TCEP Project No.: 439-080-15

ADDENDUM NO. 3

**Lied Science & Mathematics Building
Rooms B100 & 209
Renovation**

Doane College
1014 Boswell Avenue
Crete, Nebraska
TCEP No.: 439-080-15

Item 3-1: M1.01 Basement & First Floor HVAC Plans

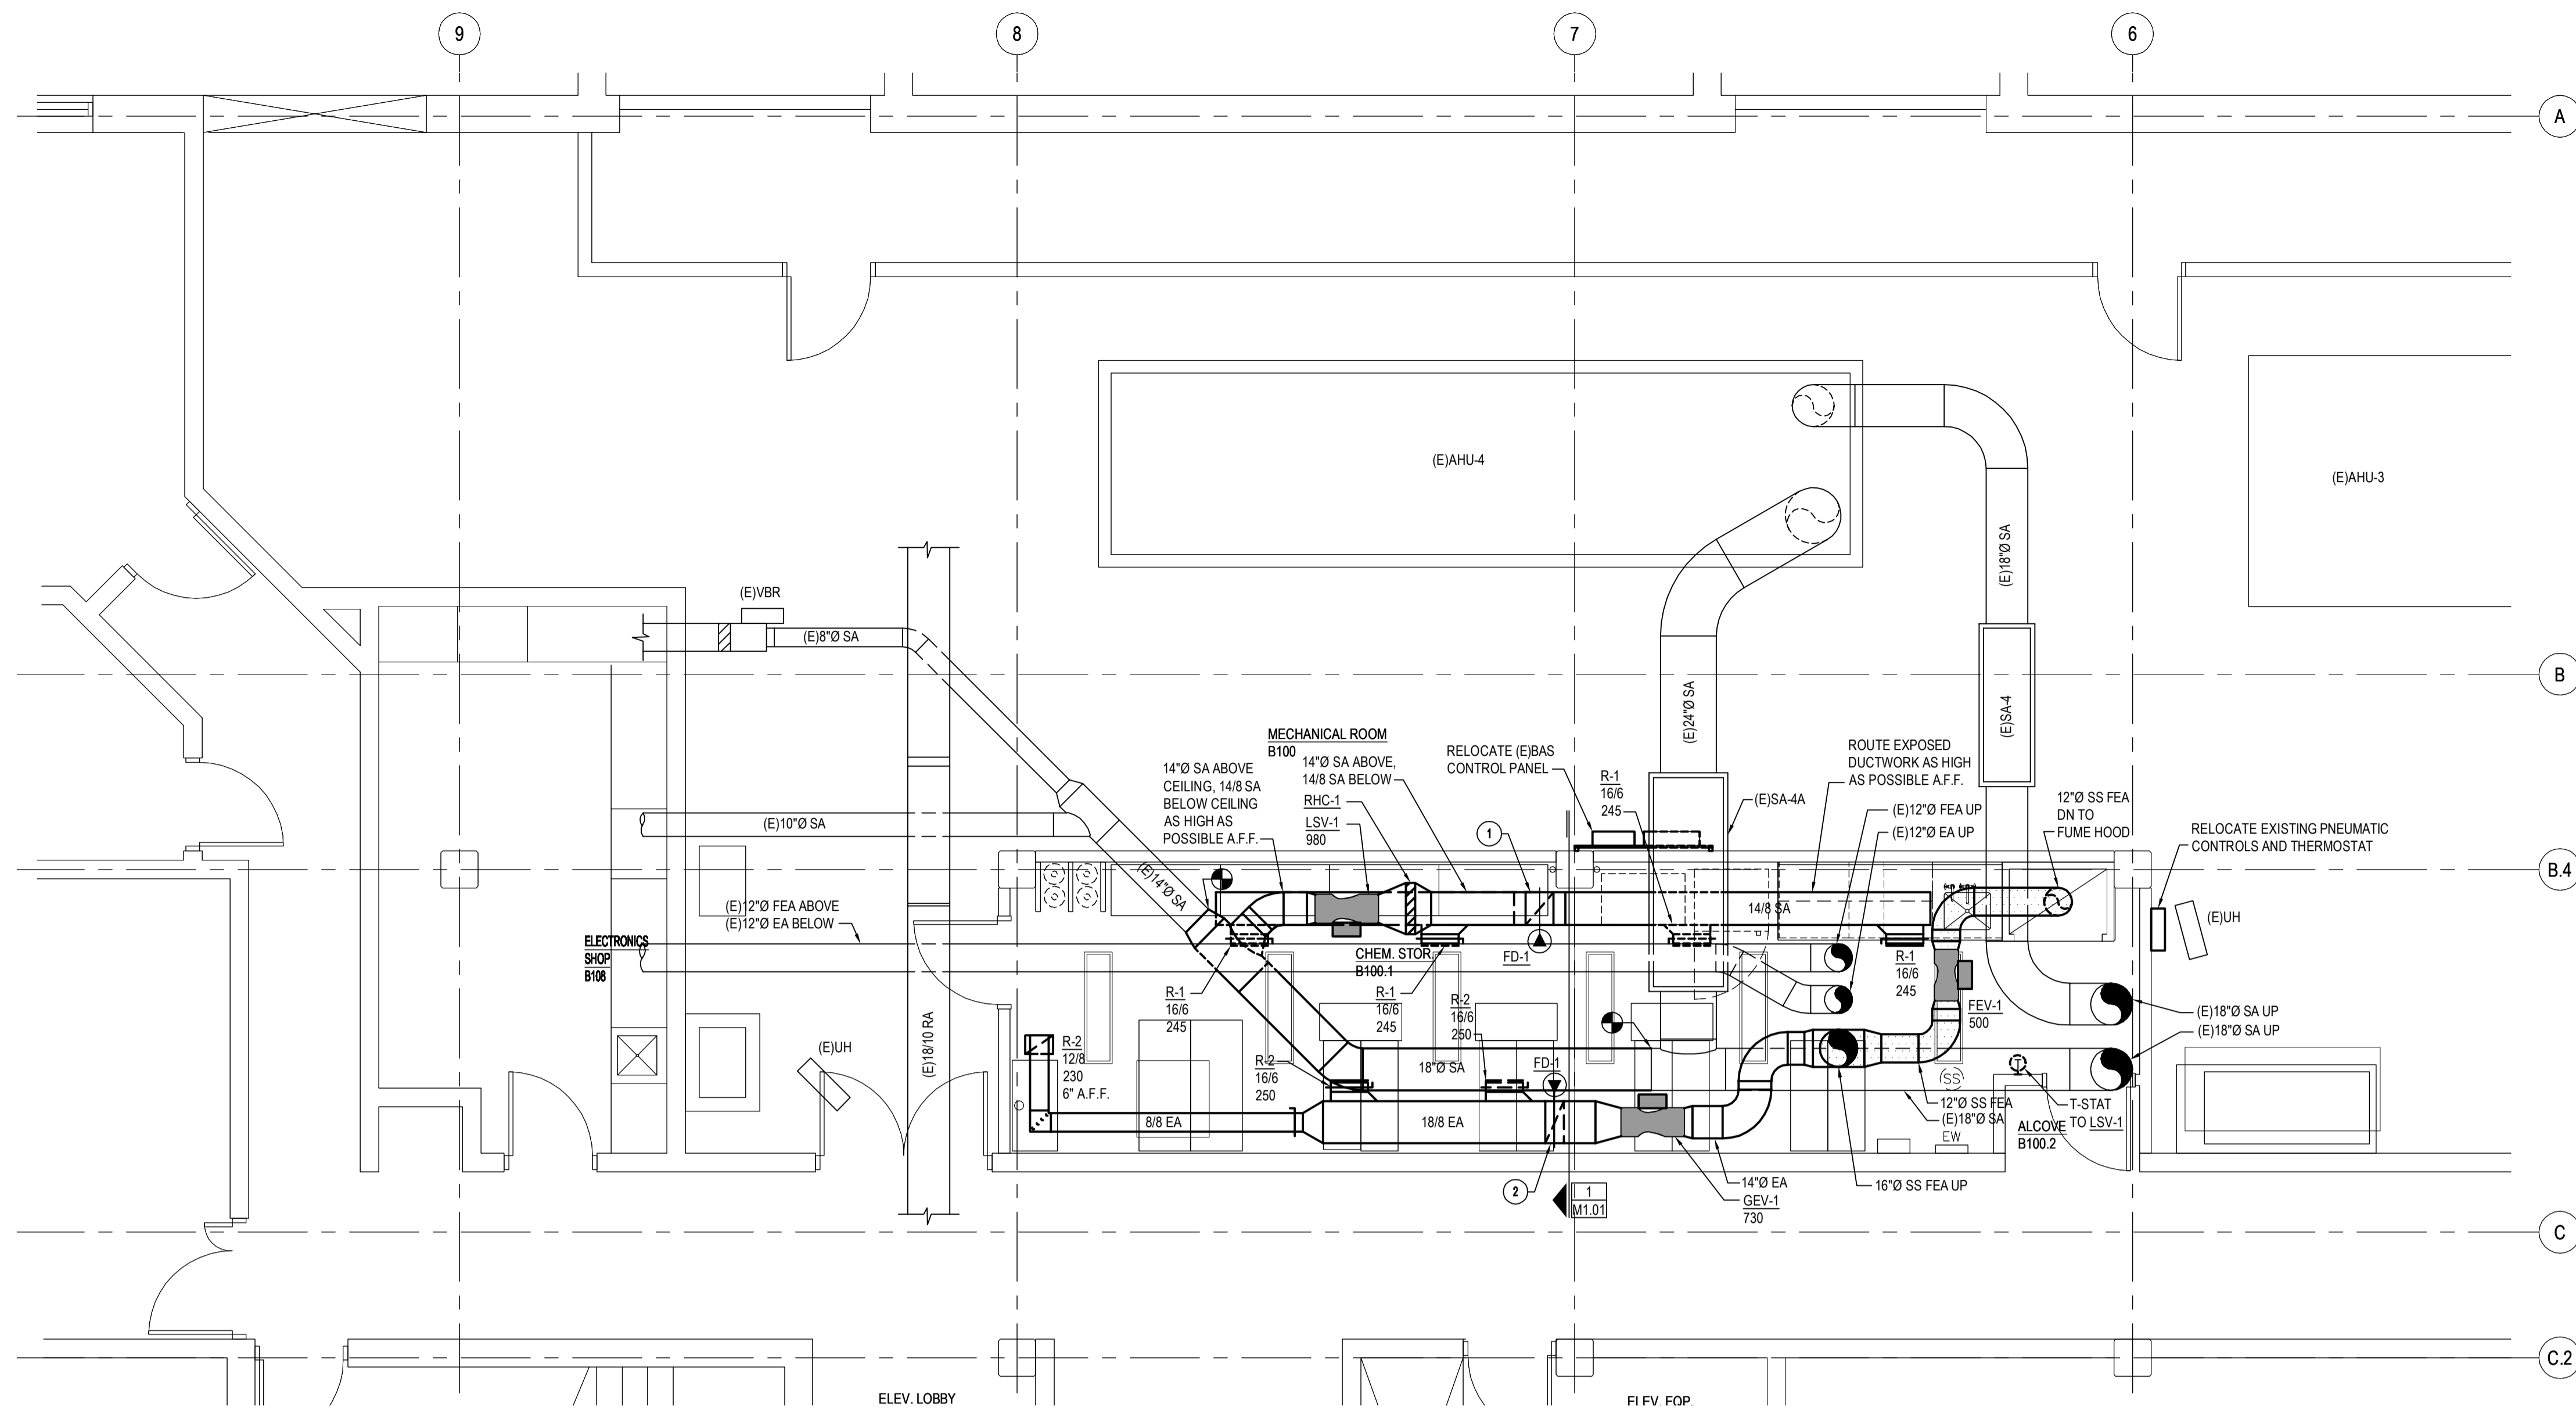
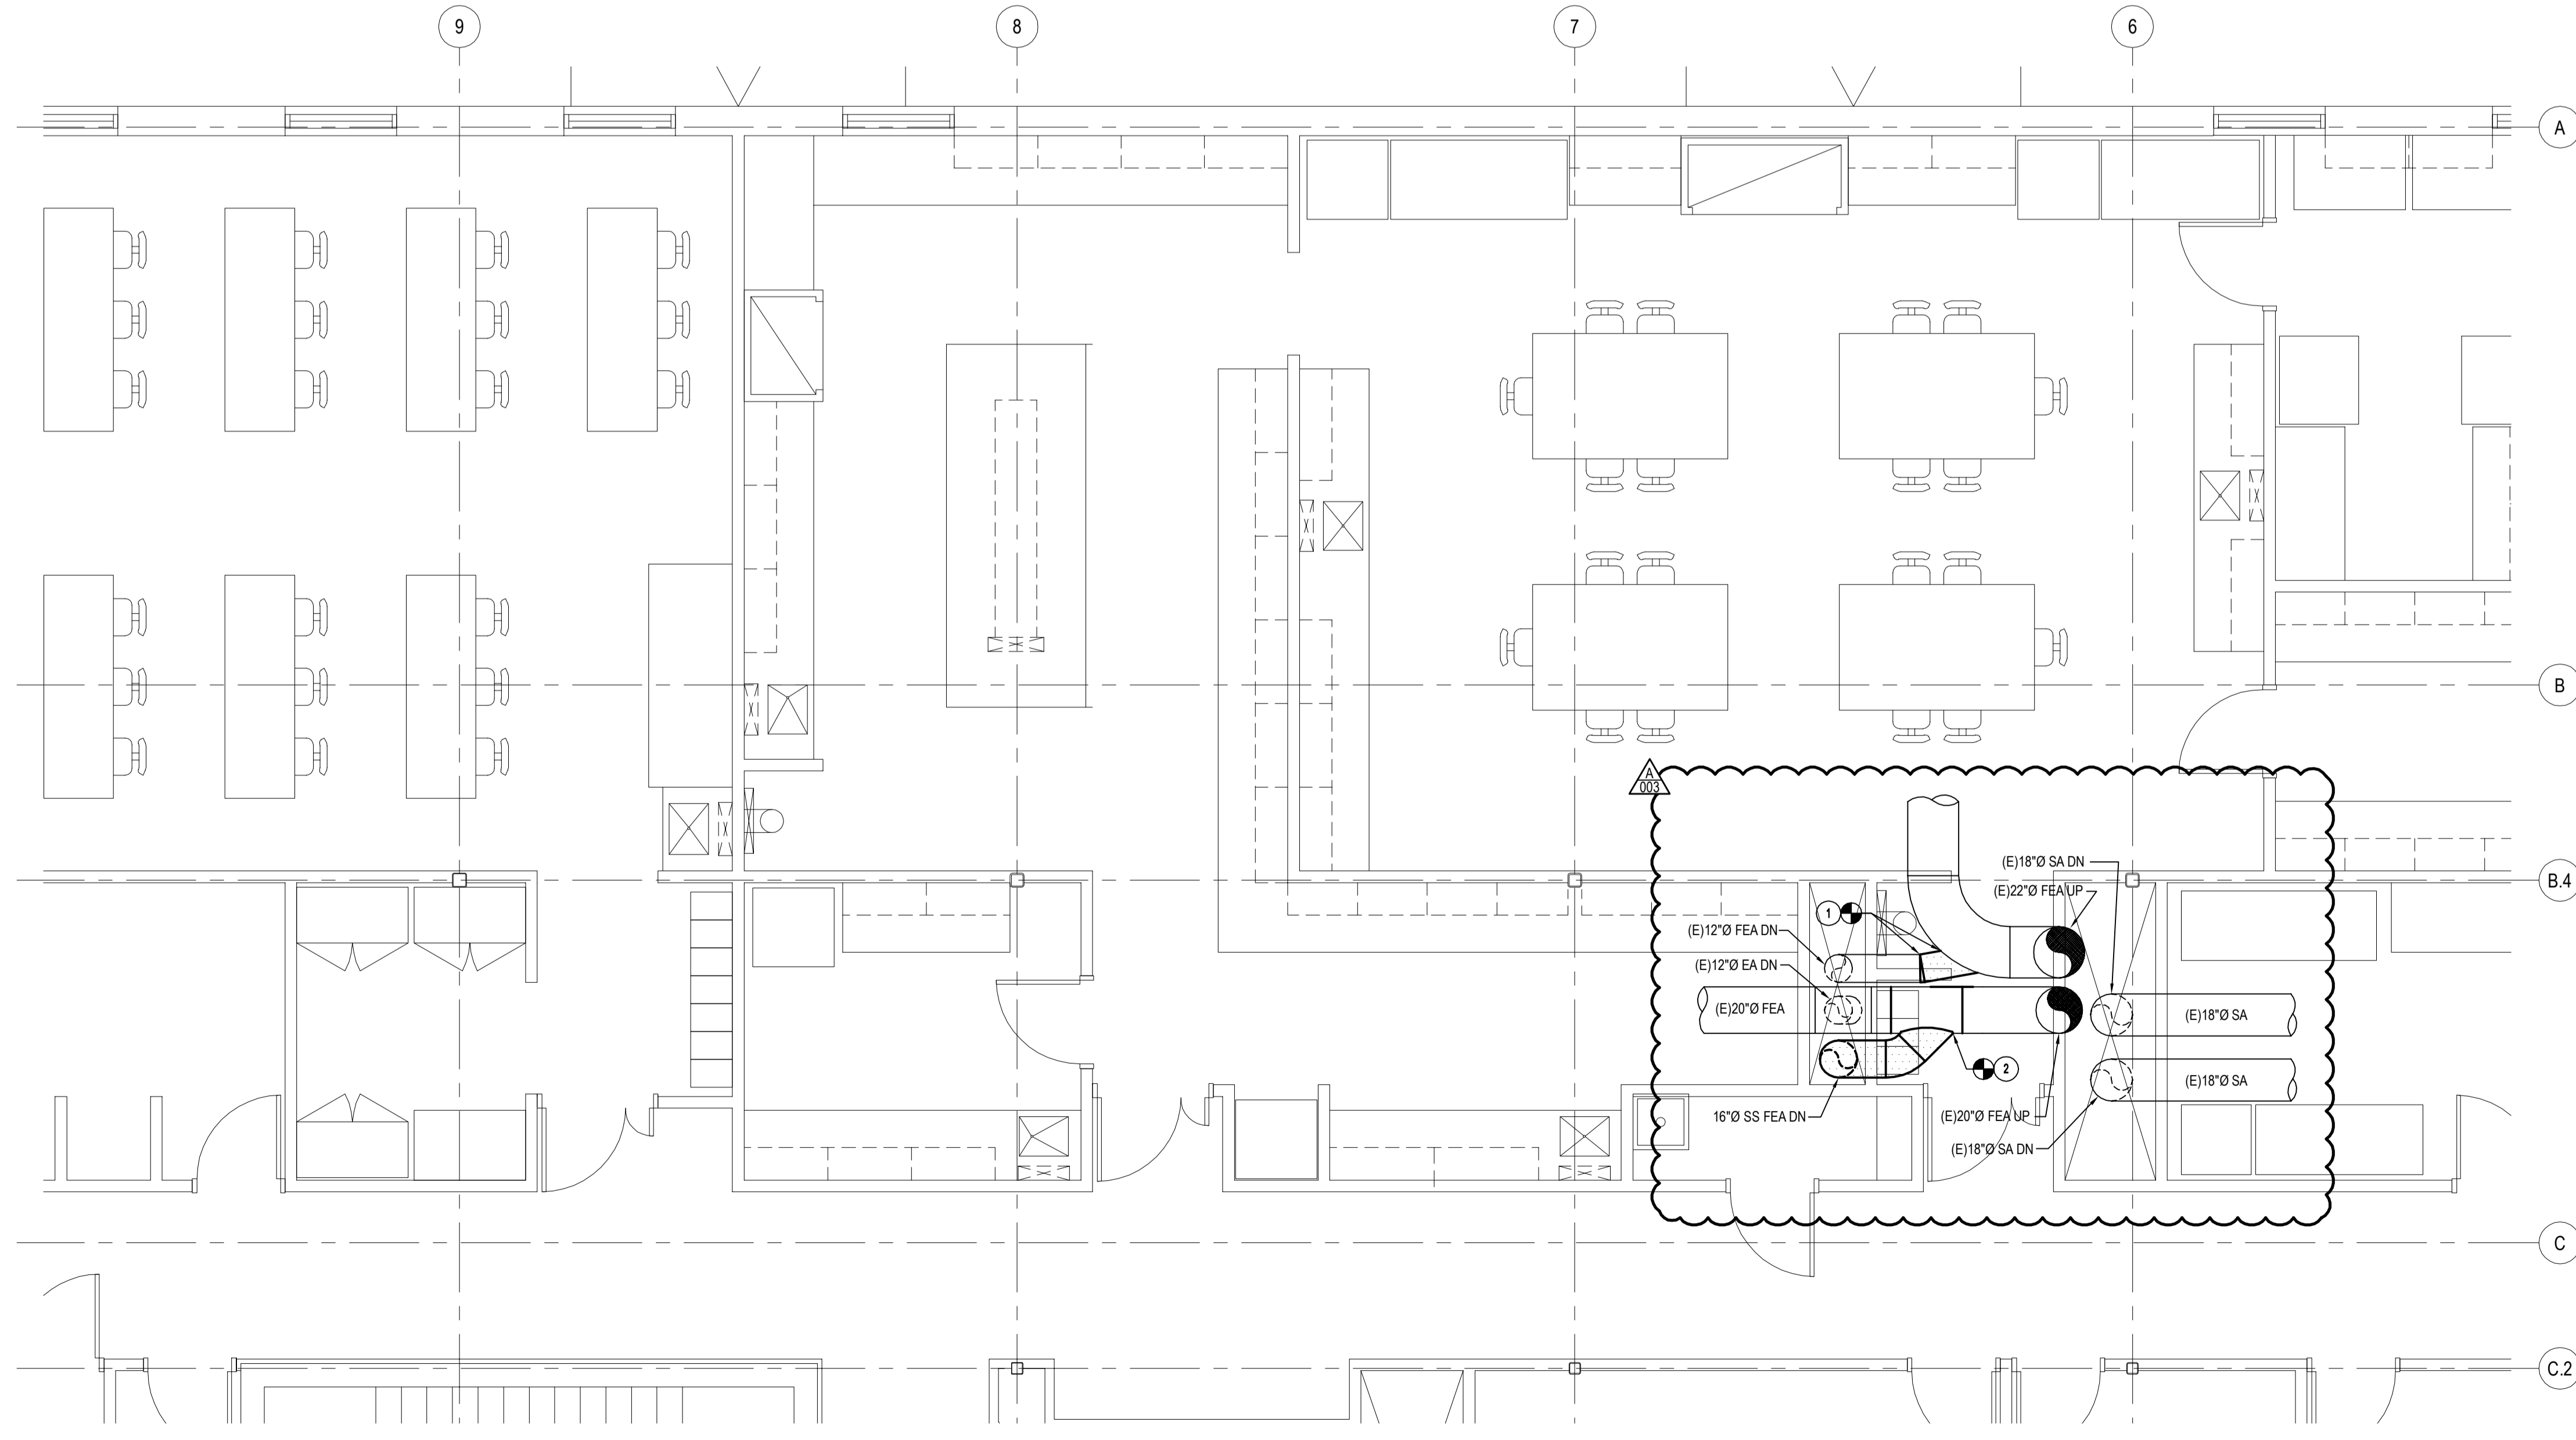
Sheet M1.01 has been reissued in its entirety to show changes to exhaust air ductwork on the First Floor HVAC Plan. (E)12"Ø FEA ductwork shall be rerouted and tied into (E)22"Ø FEA ductwork. New 16"Ø SS FEA ductwork shall be tied into (E)20"Ø FEA ductwork in lieu of routing 16"Ø SS FEA ductwork up to penthouse.

- ① (E)12"0 FEA DUCTWORK TO BE REROUTED AND TIED INTO (E)22"0 FEA DUCTWORK. PATCH AND REPAIR (E)20"0 FEA DUCTWORK.
- ② 16"0 SS FEA DUCTWORK TO BE TIED INTO (E)20"0 FEA DUCTWORK.

Item 3-2: M1.02 Second Floor & Penthouse HVAC Plans

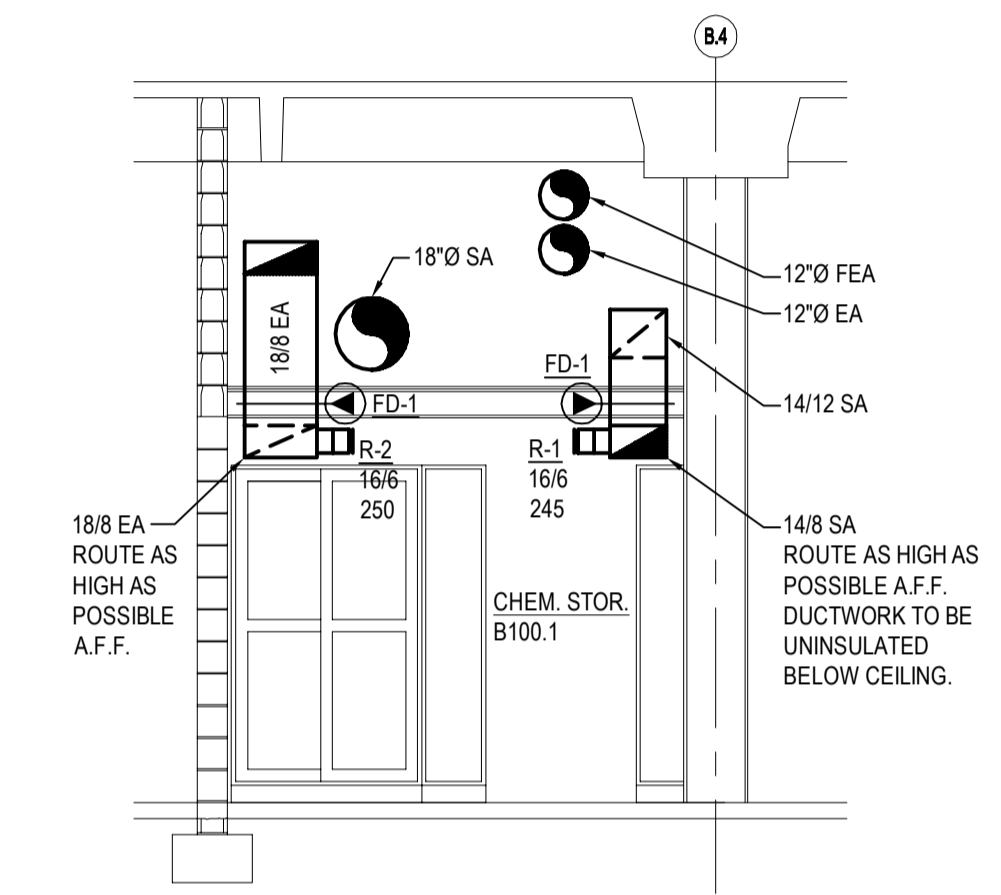
Sheet M1.02 has been issued in its entirety to show the removal of the 16"Ø SS FEA ductwork that was previously shown to be routed up to penthouse and tied into (E)Heat Recovery Unit #4. The change is reflected on both the Second Floor HVAC Plan and the Mechanical Penthouse Plan.
